**Subject:** Ford Comments  
**Attachments:** Ford Comments Non CBI Dec 2016.pdf; Alliance\_of\_Automobile\_Manufacturers\_Comments\_on\_Draft\_TAR\_2.pdf; Ford Response to the Draft Technical Assessment Report September 26 2016 final.pdf

Alliance of Automobile Manufacturers Comments on Draft Technical Assessment Report:  
Midterm Evaluation of Light-Duty Greenhouse Gas Emission Standards and Corporate Average  
Fuel Economy Standards for Model Years 2022-2025 (EPA-420-D-16-900, July 2016)

**Figure A-1: Comparison of NHTSA Base Engine Map to similar OEM 2.0L Benchmark Engine**

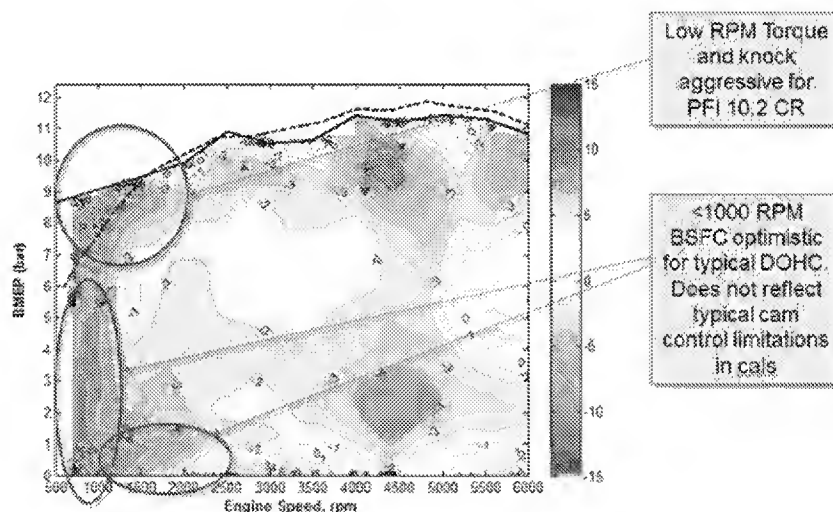
Figures A-1 and A-2 below capture the BSFC delta comparison with the key findings. Figure A-1 is a comparison to an original equipment manufacturer (OEM) benchmark 2.0L, four cylinder (cyl), naturally aspirated (NA), PFI, DOHC, dual cam variable valve timing (VVT), 10.2 CR engine. Figure A-2 is a comparison to a Honda Accord 2.4L, 4cyl, NA, gasoline direct injected (GDI), DOHC, VVT, 2-step VVL, 11.1 CR engine benchmarked by the United States Council for Automotive Research (USCAR). These comparisons illustrate the optimistic assumptions in the NHTSA Base Engine Map, as the efficiency of the NHTSA Base Engine Map is similar to a production engine with much more technology.

**Figure A-3: Comparison of IAV Gasoline Engine2 Map to NHTSA Base Engine Map**

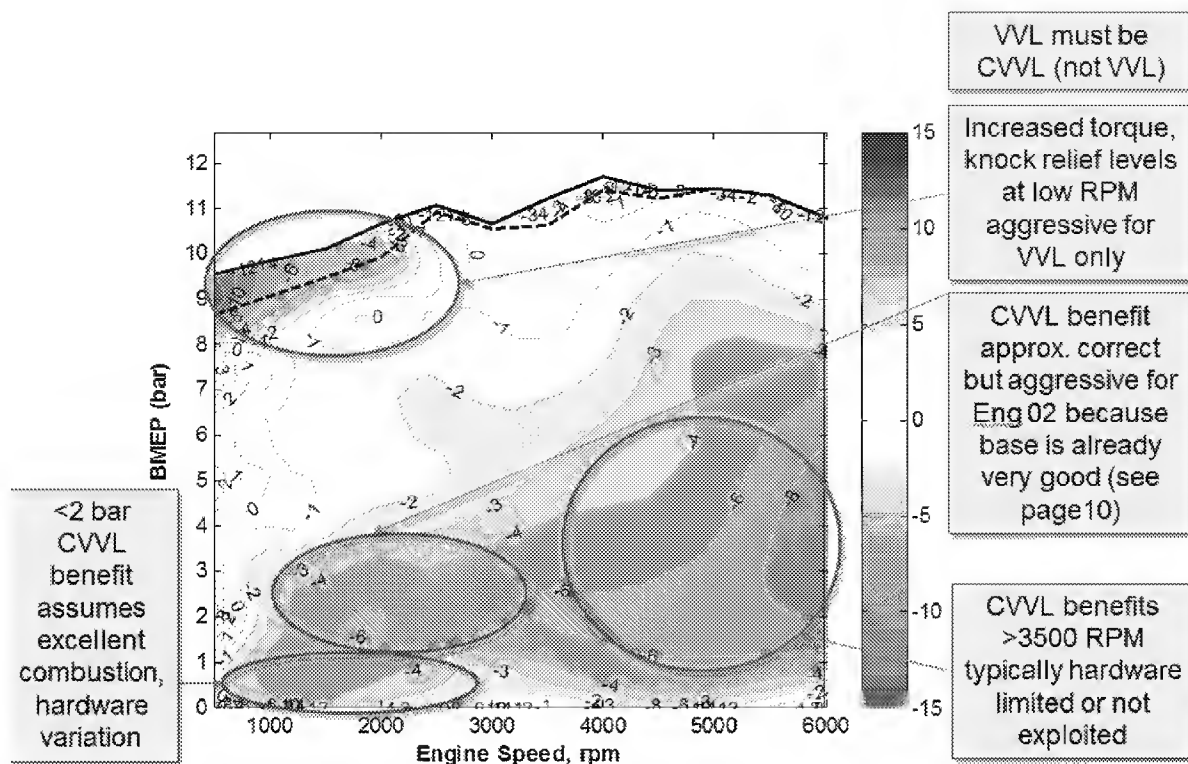
Figure A-3 compares the BSFC of the NHTSA Base Engine Map to the IAV Gasoline Engine2 Map with the key findings highlighted.

Figure A-4: Comparison of IAV Engine3 Map to IAV Engine2 Map

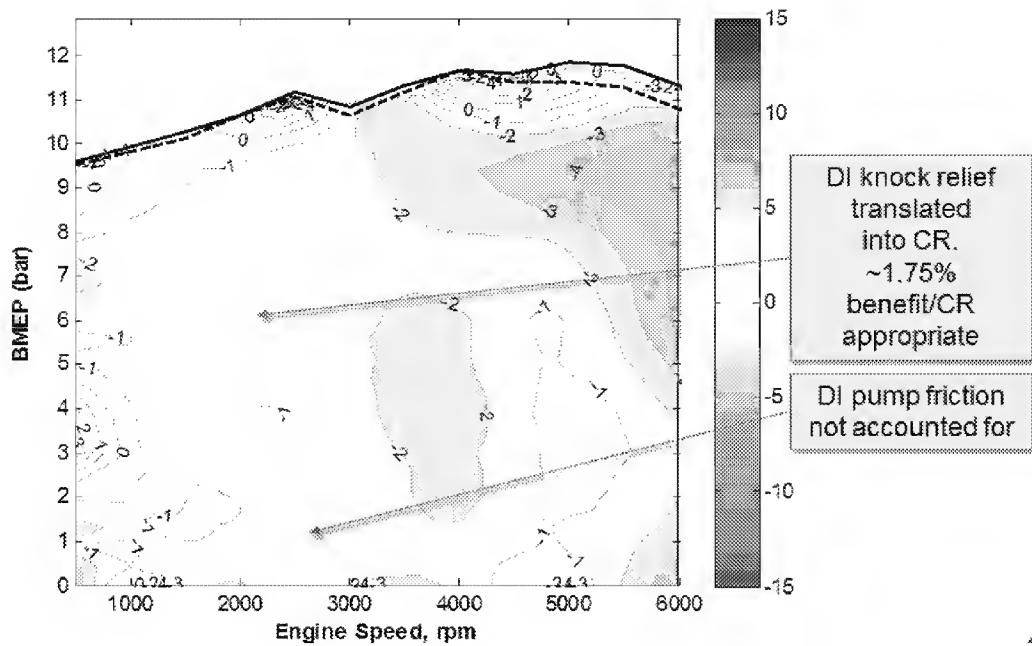
- The GDI pump friction isn't properly taken into account (Figure 1-4).
- Optimistic knock relief assumptions are used (Figure 1-4).
- Aggressive CVVL assumptions for low load operation were made across the speed band (Figure 1-5).
- The pumping work reduction is overstated, especially considering that the benchmark Honda engine used for comparison here is already a 2-Step VVL engine (Figure 1-5).

Figures A-4 and A-5 below capture the BSFC comparison with the key findings. Figure A-4 is a comparison to IAV Engine2 Map to isolate estimated GDI benefits. Figure A-5 is a comparison to the USCAR benchmarked Honda 2.4L engine with similar technologies.

Figure A-13: Comparison between IAV Gasoline Engine12 Map and IAV Gasoline Engine13 Map;  
Displacement Change without Full Modeling Questionable

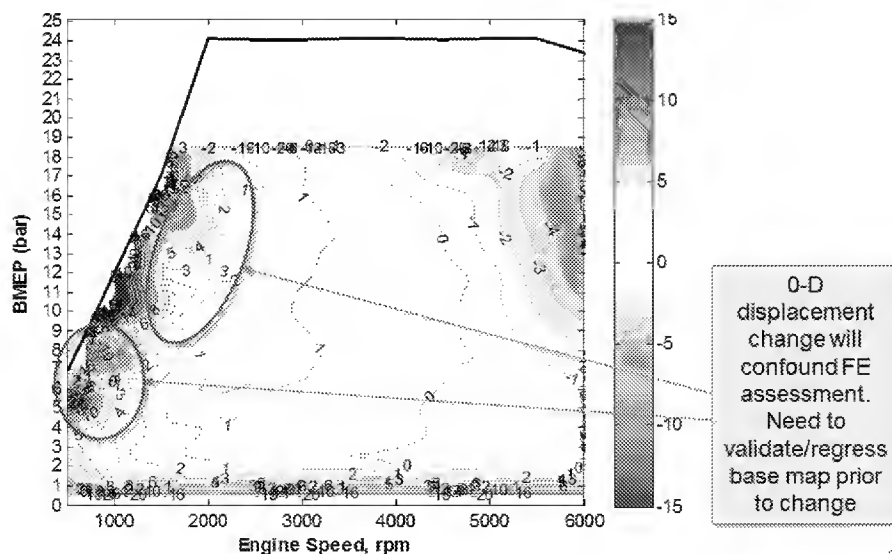
Figure A-13 captures the effect of a 0-D displacement change from 1.6L to 1.2L (downsizing effect).

**Figure A-14: IAV Gasoline Engine14 Map - Aggressive Fuel Surface With Atypical Results**

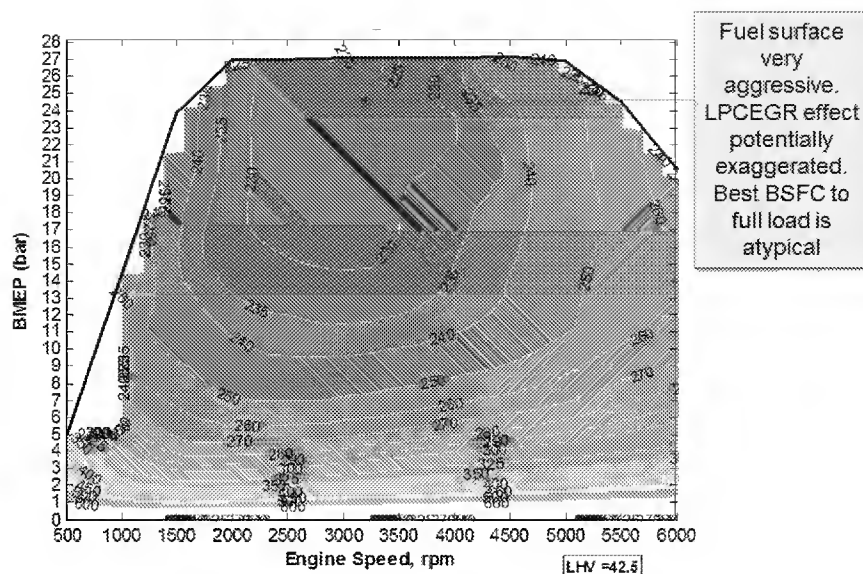
Figure A-14 below illustrates the effect of aggressive LPCEGR on the 1.0L 3-cylinder engine.

**Figure A-15: Lumped Parameter Model compared to Test Data**

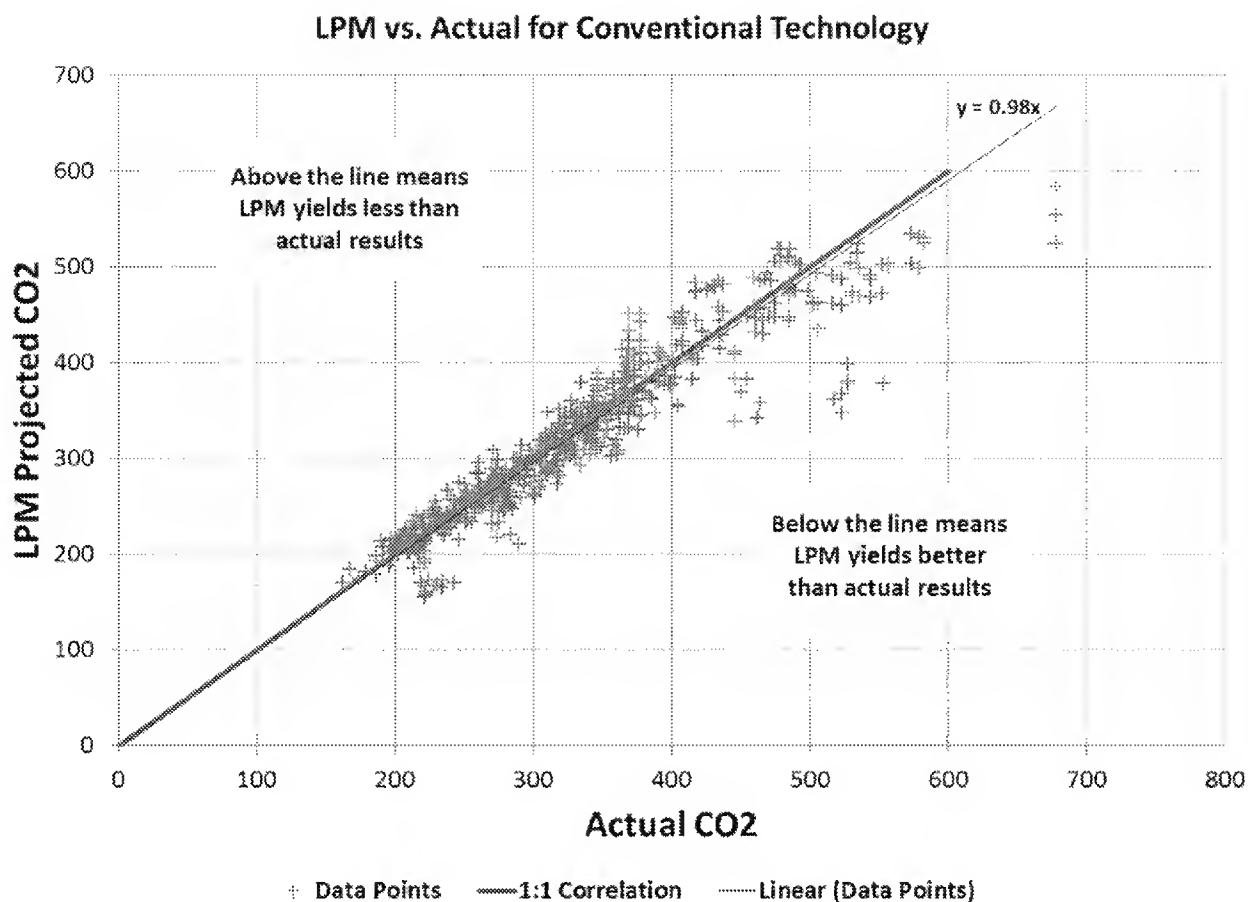
The results of this process, after sorting for conventional technologies (no hybrids, turbocharged engines, or eight-speed transmissions), are plotted below in Figure A-15. In this and the following figures, results below the line show data where the LPM predicted lower CO<sub>2</sub> than the vehicle actually emitted. Conversely, points above the line show when the vehicle was better than the LPM estimate. The standard error for this data is 31 g/mi, but the overall slope calculated as a best-fit line is about 2% from actual.

**Figure A-16: Lumped Parameter Model compared to Test Data of Vehicles with 8-Speed Transmissions**

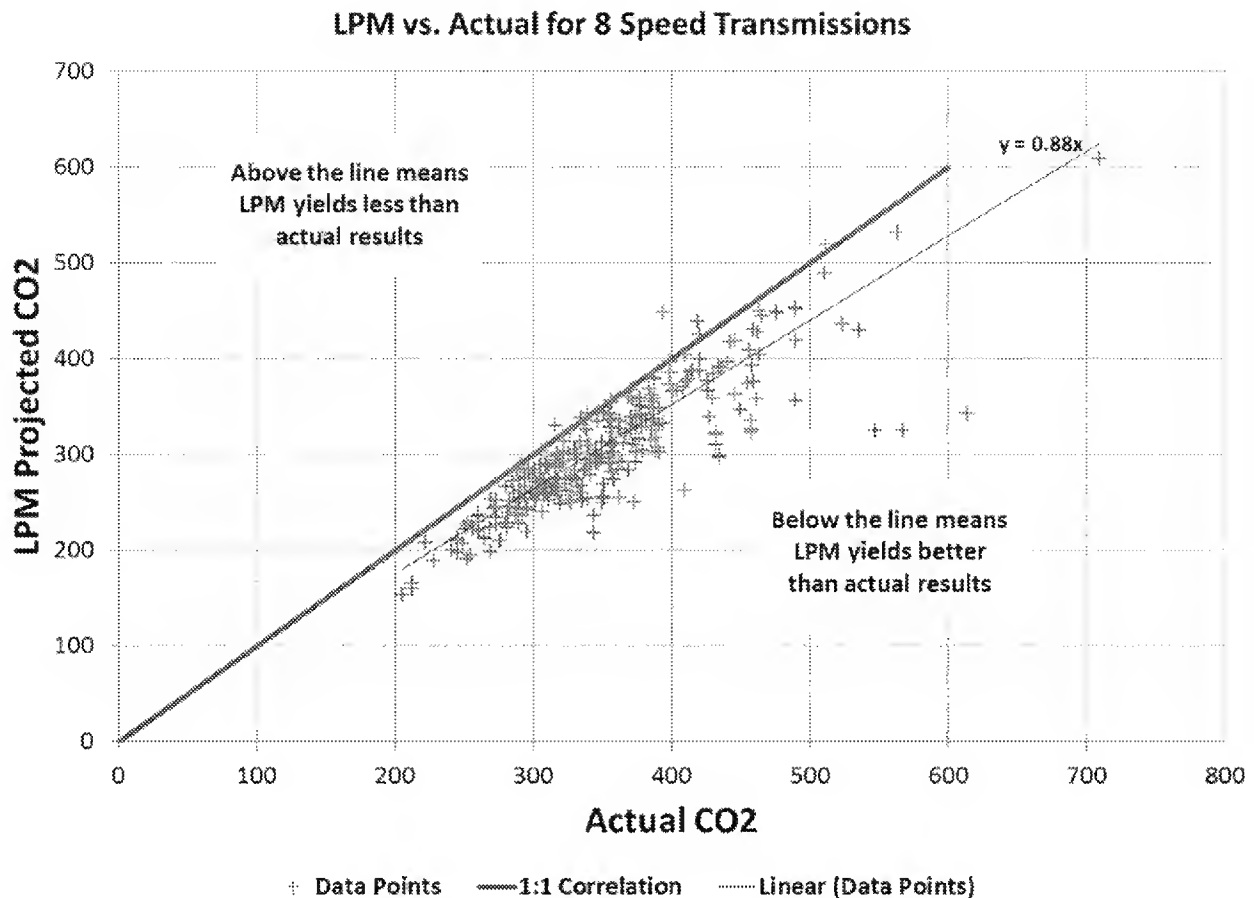
Figure A-16 shows the data after filtering for only eight-speed transmissions. Here the standard error has increased to 49 g/mi, but of greater concern is the change in slope of the best-fit line. The overall trend shows that the LPM is more optimistic by 12% than what manufacturers have, on average, been able to deliver. This is the powertrain technology, aside from variable valve timing, with the highest projected penetration (~90%) from the OMEGA model.<sup>75</sup>

**Figure B-1: Comparison of Mazda SkyActiv 2.0 L - EPA Data (96+ RON) vs. USCAR Data (91 RON)**

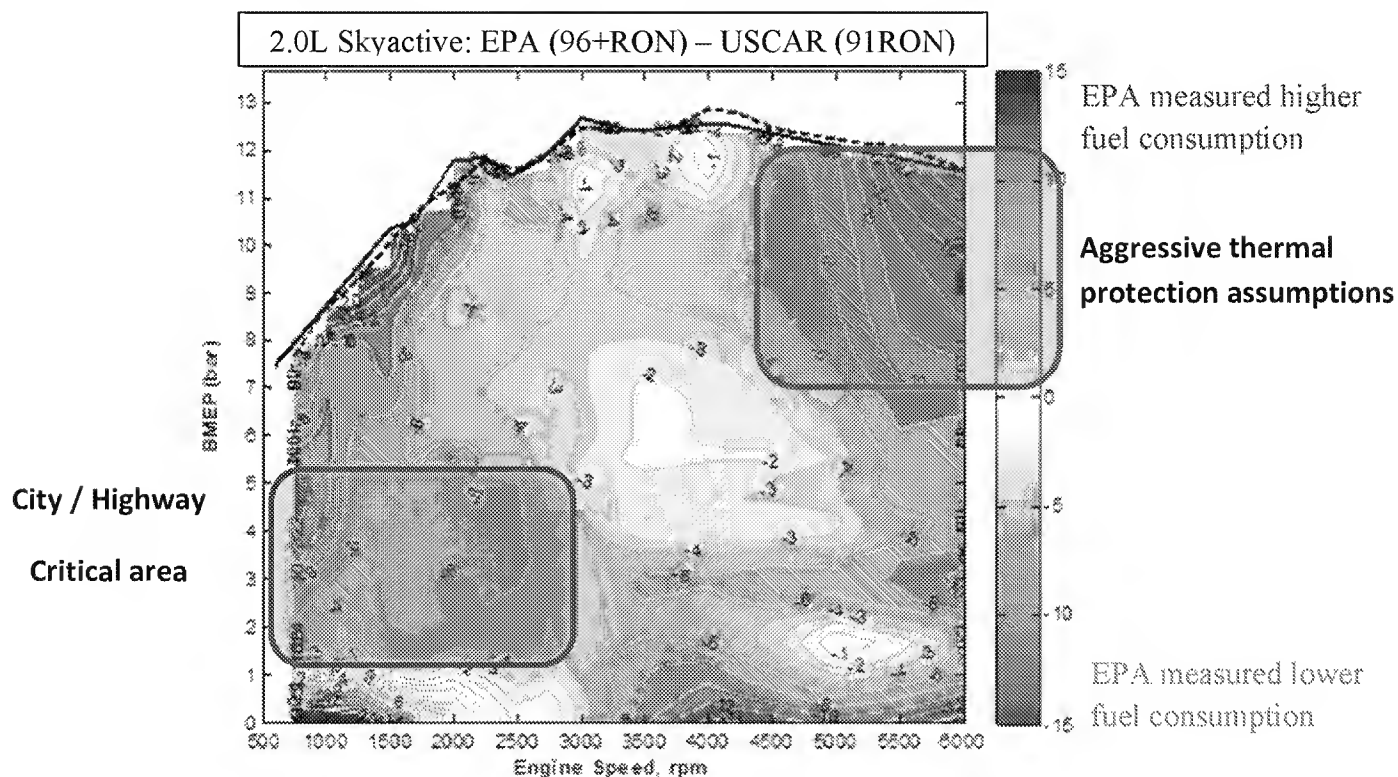
The differences between the USCAR and EPA fuel maps described in the paragraph above are shown in Figure B-1 below. The green areas in the plot (where EPA projects lower fuel consumption than USCAR) are due to knock limit improvements associated with EPA's use of premium fuel for benchmarking. The octane advantage can clearly be seen in the comparison, and results in engine fuel map benefits that cannot be achieved with market grade regular and Tier 3 certification test fuels.

**Figure B-2: ATK2 Torque Curve Discrepancy between SAE and ALPHA<sup>98,99</sup>**

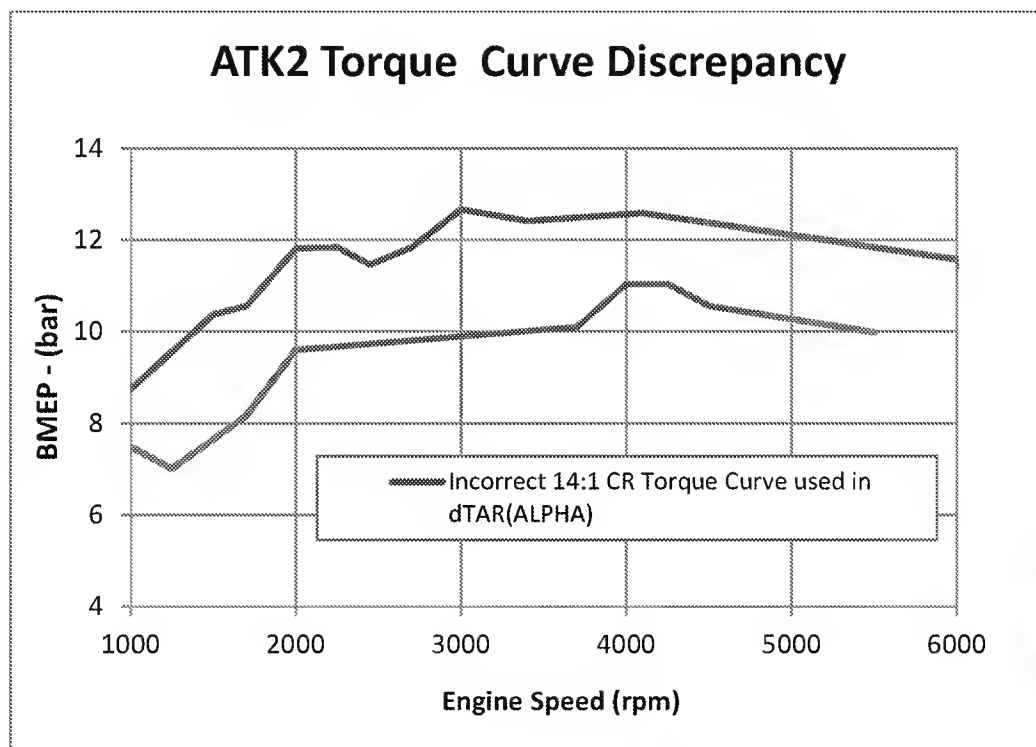
Additionally, it appears that there was a serious clerical error in translating the GT-POWER full load torque data to ALPHA which was then carried into the LPM's calibration. We note that in the SAE paper 2016-01-0565<sup>96</sup> the GT-POWER model correctly limited the full load torque of the engine due to knock onset. However, it is not clear that this significant reduction in torque was translated to the Advanced Atkinson Tech Package used in ALPHA simulation work which was subsequently used to calibrate the LPM model. This error incorrectly leads to exercising downsizing options because the performance metrics could theoretically be met with the torque that should have been limited as shown in SAE paper 2016-01-0565.<sup>97</sup> The net result is a large overestimation of the benefit with the Advanced Atkinson Tech Package. The modeled performance would be further degraded if correct CEGR assumptions were used as discussed below. Figure B-2 compares the two torque curves, baseline Atkinson, and the Advanced Atkinson Tech Package.

**Figure B-5: Effects of D/M on Downsizing Benefit: CAFE Unadjusted Combined Fuel Economy<sup>107</sup>**

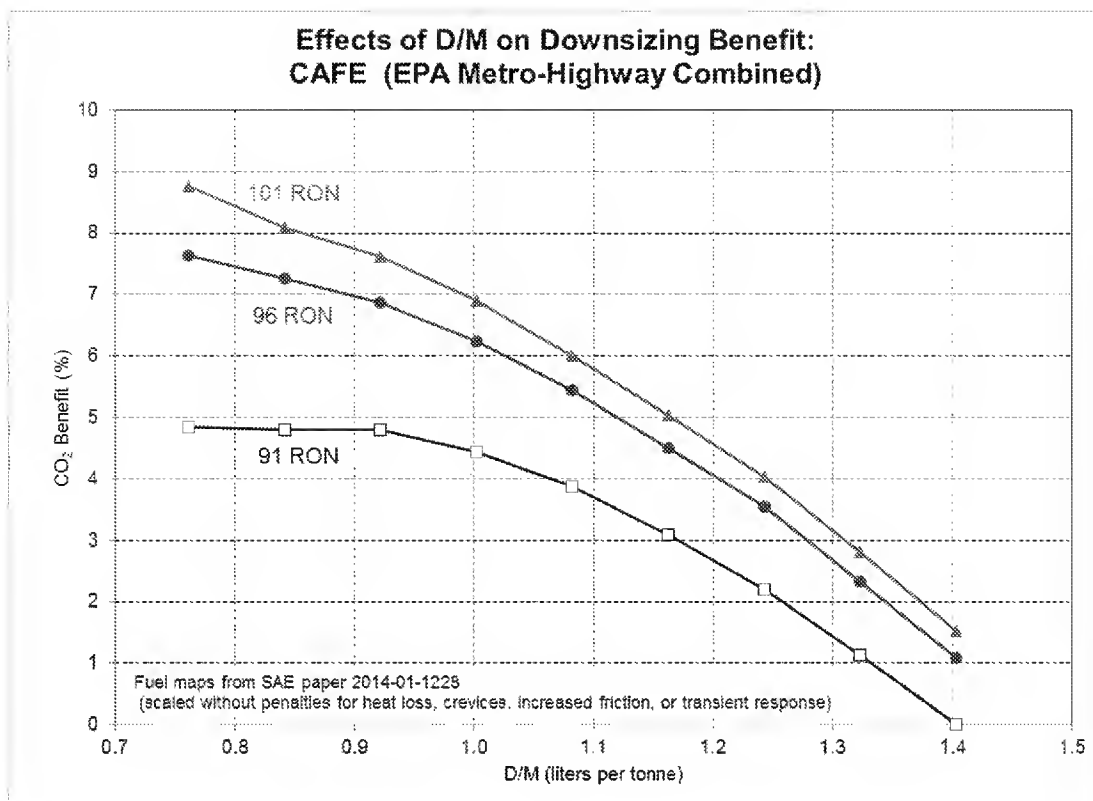
Fuel octane limitations are further demonstrated in Figure B-5 which shows large impacts on fuel consumption at high-load conditions. Note that with moderate downsizing, engine efficiency increases, but aggressive downsizing results in degraded efficiency. This is particularly important because in many cases the Agencies' downsizing assumptions appear to be based on maximizing the efficiency over city and highway test cycles while ignoring efficiency reduction during higher-load driving conditions (for example US06 and high-speed interstate driving conditions). Automakers must consider customer drivability and performance acceptance including high-load driving conditions when determining the appropriate level of downsizing, and cannot implement the level of downsizing based on analysis that is derived solely on operation during certification cycles. Using 91 RON fuel (e.g. Tier 3 fuel) there is no further CO<sub>2</sub> benefit below a displacement-over-mass ratio (D/M) of about 0.9. However, as shown by the 96 RON and 101 RON data in the figure below, the Agency assumptions based on higher-octane fuel would indicate that additional downsizing beyond 0.9 D/M still yields reductions in CO<sub>2</sub>.

**Figure B-6 Effects of D/M on Downsizing Benefit: On-Road Fuel Economy (Highway Bag of US06 Cycle)<sup>108</sup>**

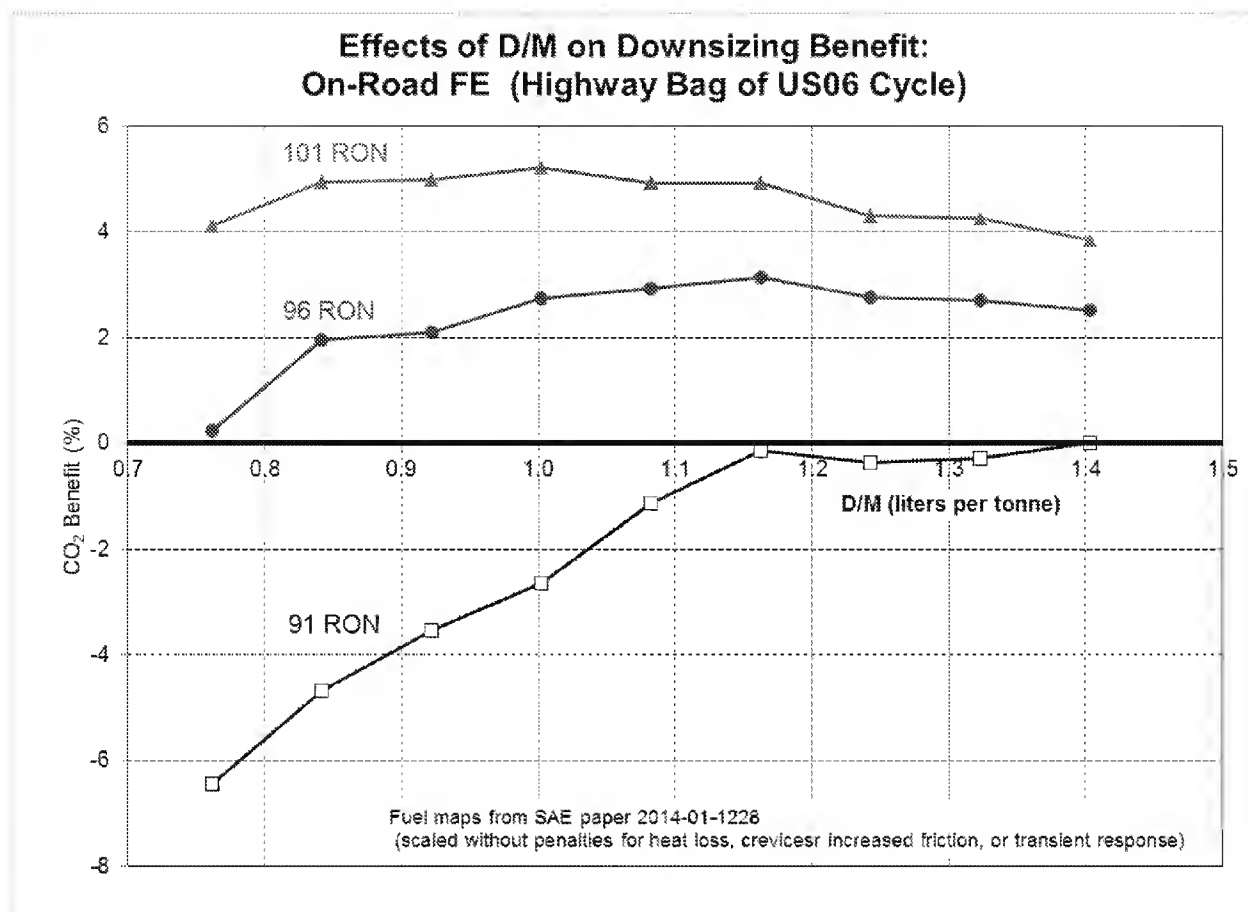
Even more importantly, Figure B-6 below shows that overestimating the degree of downsizing will actually decrease fuel efficiency at higher loads (high-speed on-road driving, US06). This effect is amplified with higher octane fuels. The figure shows decreases in CO<sub>2</sub> benefit for engines with a D/M of 1.2 while using 91 RON fuel.
